Access Compliance Report Public Rights-of-Way (Curb Ramps)

Main Street: CRAWFORD_CANYON_RD		Cross Street: BARRETT_LN		Location:	SE
ADA ID: RPRK211007175924	Ramp Type:Type 1 - Perpendicular	Initial Pass/Fail: Pass	Overall Compliance: No	Severity Score:	12

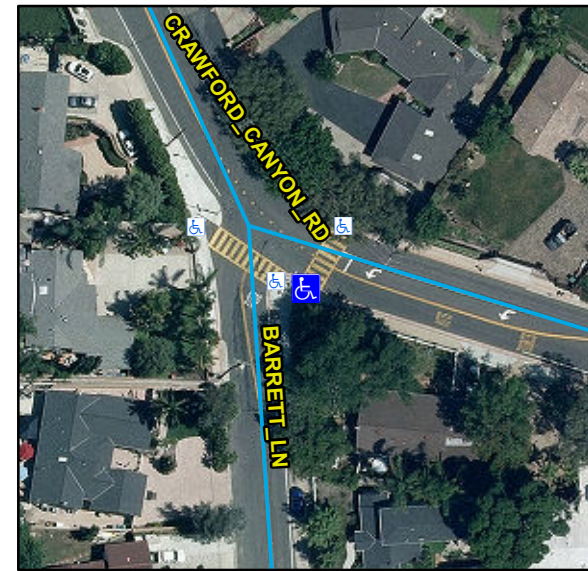
Compliance	Description	Data	Compliance	Description	Data
N/A	Ramp Length (in)	48	N/A	Flare Type LT	
Yes	Ramp Width (in)	48			Sloped
Yes	Ramp Run Slope (%)	7.5	N/A	Flare Slope LT (%)	16.1
Yes	Ramp Cross Slope (%)	1.5	N/A	Flare Traversable LT	No
N/A	Landing Present	Yes	N/A	Flare Type RT	
N/A	Landing Length (in)	35			Sloped
Yes	Landing Width (in)	48	N/A	Flare Slope RT (%)	10.5
No	Landing Run Slope (%)	3.2	N/A	Flare Traversable RT	No
Yes	Landing Cross Slope (%)	1.5	Yes	DWS Provided	Yes
N/A	Landing Movement Obstructed?	Yes	Yes	DWS Contrast	Yes
	Landing Movement Type	Guard Rail	Yes	DWS Length (in)	36
N/A	Landing Shared	No	Yes	DWS Full Width	Yes
N/A	Clear Space	N/A	Yes	DWS Offset Left (in)	0
N/A	Clear Space To Crosswalk (in)	N/A	Yes	DWS Offset Right (in)	N/A
N/A	Marked Crosswalk 1	Yes	N/A	Marked Crosswalk 2	N/A
	Crossing 1 Direction	NE		Crossing 2 Direction	N/A
	Marked Crosswalk 1 Width (in)	144		Marked Crosswalk 2 Width (in)	N/A

Yes	Ramp Inside Crosswalk 1	Yes	Yes	Ramp Inside Crosswalk 2	N/A
	Crossing 1 Slope (%)	12.6		Crossing 2 Slope (%)	N/A
	Crossing 1 Cross Slope (%)	1.4		Crossing 2 Cross Slope (%)	N/A
Yes	Gutter Ponding	No	No	Curb Slope	13.5
Yes	Gutter Lip Height (in)	0		Road Run Slope (%)	N/A
No	Gutter Run Slope (%)	9		Road Cross Slope (%)	N/A
Yes	Gutter Cross Slope (%)	0.3			
Yes	Overall Surface Condition: Acceptable		Yes	Perp Joint Present	Yes
	Cross Gutter Present?	No		Spandrel Present?	No
	Replace Cross Gutter?	N/A		Replace Spandrel?	N/A

Remove & Replace Entire Ramp. Remove & Replace Gutter.
